Amendments to the Drawings:

Application No. 10/674,739
Reply to Office Action dated 9/30/05
Annotated Sheet Showing Changes

Fig. 1A

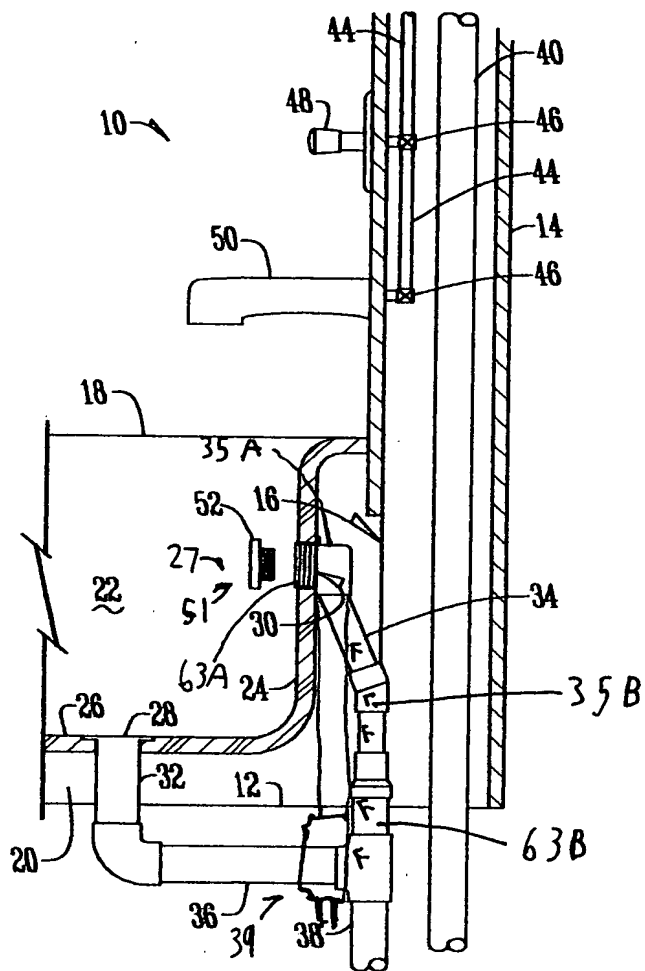
The attached sheets of drawings include changes to Page 1 of 2 and Page 2 of 2 with changes to Fig. 1A and Fig. 3. In Fig. 1A the drain pipe 34 is drawn as L-shaped consistent with Fig. 3 and numerals have been added. In Fig. 3 numerals have been added.

The Examiner has objected to the drawings under 37 C.F.R. § 1.83(a). Specifically the Examiner raises four issues. First, the Examiner asserts that the drawings do not show a drain pipe having an inverted L-shape as called for by claim 1. Fig. 1A has been amended to provide a drain pipe of one piece construction that has an L-shape. This L-shaped drain pipe is shown in Fig. 3 and thus the drawing change has proper antecedent basis in the original disclosure. Thus, this drawing rejection is considered overcome.

downwardly for connection to a fluid drain system. As discussed above, Fig. 1A has been amended to make the overflow drain pipe an L-shape such that it has a horizontal portion 35A and a vertical portion 35B that extends to a fluid drain system 39. Additionally, the L-shaped description of the drain pipe along with the description of the horizontal leg and the vertical leg extending to the fluid system has been added in an amendment to the specification. This amendment to the drawing, Fig. 1A and to the specification gains antecedent basis in the original claims and in Fig. 3. Again, specifically Fig. 3 shows the overflow drain pipe 34 that has an L-shape with a horizontal portion 35A and a vertical portion 35B. As seen in Fig. 3, the pipe includes the threaded end portion that is part of the horizontal leg. Thus, the amendments to the drawings and specification has proper antecedent basis within the originally filed application.

The Examiner has objected to the phrase "fluid drain system" as not shown in the drawings. The fluid drain system 39 comprises the horizontal pipe 36 and drain pipe 38. This description has been added to the specification and numeral 39 has been added to Fig. 1A to show the same. As the horizontal pipe 36 and the drain pipe 38 are both presented in original Fig. 1A, this amendment to the drawings and specification has proper antecedent basis in the original specification.

30. Applicant has also amended the specification to add the overflow drain pipe 34 also has a second end in communication with a fluid drain system 39. As seen this amendment gains antecedent basis from the claims and from Fig. 1A that has been amended to provide Figures 63A and 63B showing these elements that are properly within the original drawings. Thus no new matter has been entered and all the drawings objections are considered overcome.

The specification has been objected to for failing to provide proper antecedent basis for several claim terminologies. The first claim terminology is "an overflow system for a bathtub". The Applicant has added this limitation to page 3, line 23 of the specification and has added numeral 27 to Fig. 1A that shows the overflow system. This amendment gains antecedent basis from the original application and specifically from Fig. 1A that shows the overflow system.

The next claim limitation the Examiner objects to is "a plumbing test system". The specification at page 4, line 5 has been amended to state that with reference to Figs. 2 and 3, both Figures show parts to a plumbing test system 51. Numeral 51 has been added to Fig. 1A and thus the plumbing test system was provided in the original specification and this amendment has proper antecedent basis. Thus this objection is considered overcome.
